**Castleglenn  
Consultants**

**Re: Access Impact Assessment:  
2710 Draper Avenue, Ottawa, Ontario: Fresh Town Phase 3-2 Development**

*Exhibit 1: Fresh Towns Development; East Site of Development*

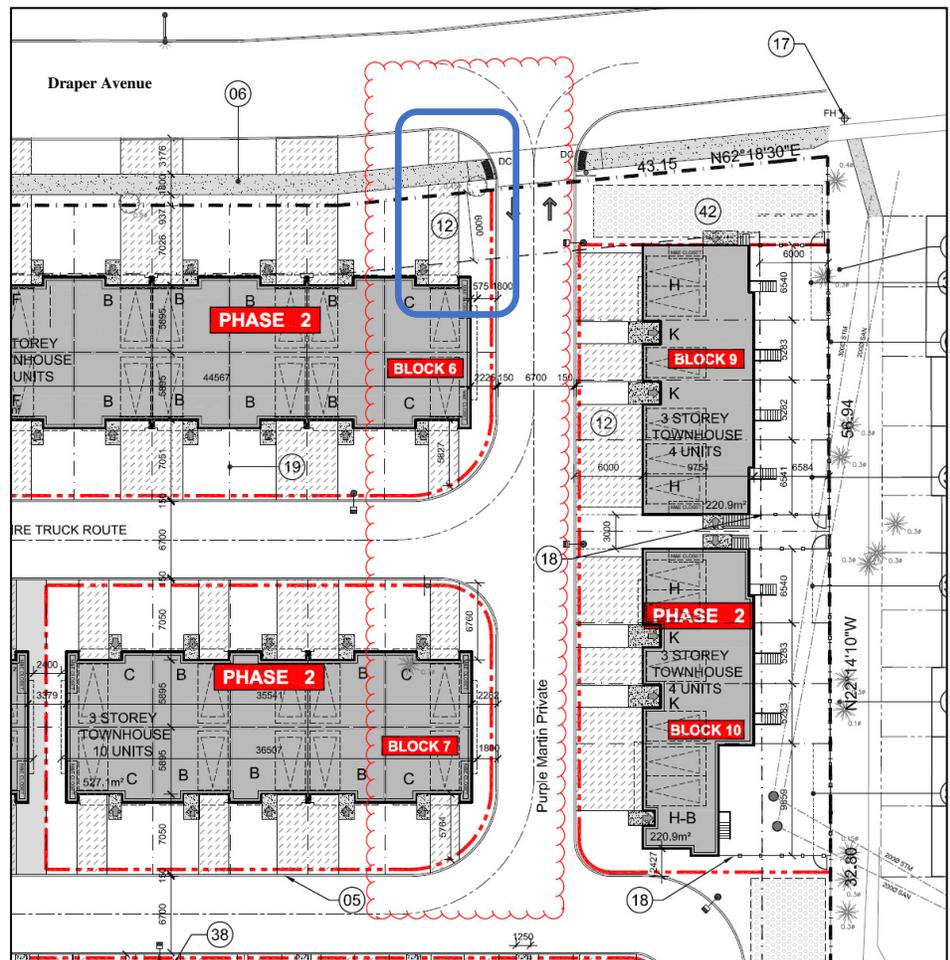
*“Block 6 and 7, all units along Purple Martin Pvt., Flip the units so that the driveways are as far away from the intersection/curb radii.”*

The driveways connecting to those roadways to the west of Purple Martin Private are not located “adjacent to a public highway” and are located well within the Fresh Towns development and facing private roads (i.e. Cherry Blossom Private and Follage Private). Therefore, a comment that suggests changes to “*all units along Purple Martin Pvt*” since the driveways do not tie into a City street, may well be considered outside the PAB.

At issue is the single end-unit driveway that connects to Draper Avenue located to the west of Purple Martin Private denoted by the blue square on Exhibit 1. The current separation between Purple Martin Pvt. and the end-unit driveway (along Draper Avenue) is 3.5m. The City of Ottawa’s Private Approach By-Law No. 2003-447 requires for multiple residential dwellings that:

- The driveways internal to the site (i.e. having access onto Cherry Blossom Private and Follage Private) should not be subject to a suggested 9m separation as these driveways connect to a private road and not a public highway.
- The proposed location of the end-unit private driveway (3.5m from Purple Martin Pvt.) is NOT anticipated to result in any traffic operation concerns. There is no operational, sightline nor queuing rationale as regards the suggested 9m separation between the single driveway and the private approach into the Fresh Town site. The proposed 3.5m separation was found to be acceptable.
- The City of Ottawa is encouraged to consider appropriate conditions related to maintenance that would ensure sightlines are not impeded.

***Exhibit 2 Sightline Assessment Along Draper Avenue***

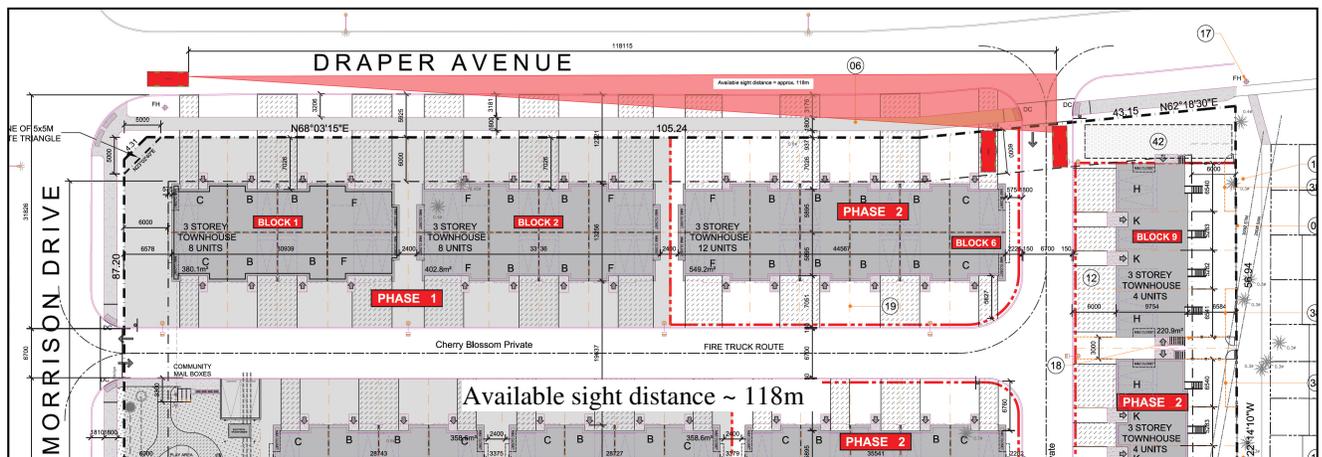
Exhibit 2 illustrates the results of a sightline analysis that was undertaken to ensure that a vehicle parked at the end-unit driveway (along Draper Avenue) does not impede the sightlines of a vehicle making a turn onto Draper Avenue from Purple Martin Pvt.

- the current proposed location of the end-unit private driveway (3.5m from Purple Martin Pvt.) is deemed acceptable and is not anticipated to result in traffic operational concerns; and
- There is sufficient sightline for a vehicle at Purple Martin Pvt. to observe vehicles all the way to the Morrison Drive/Draper Avenue intersection.
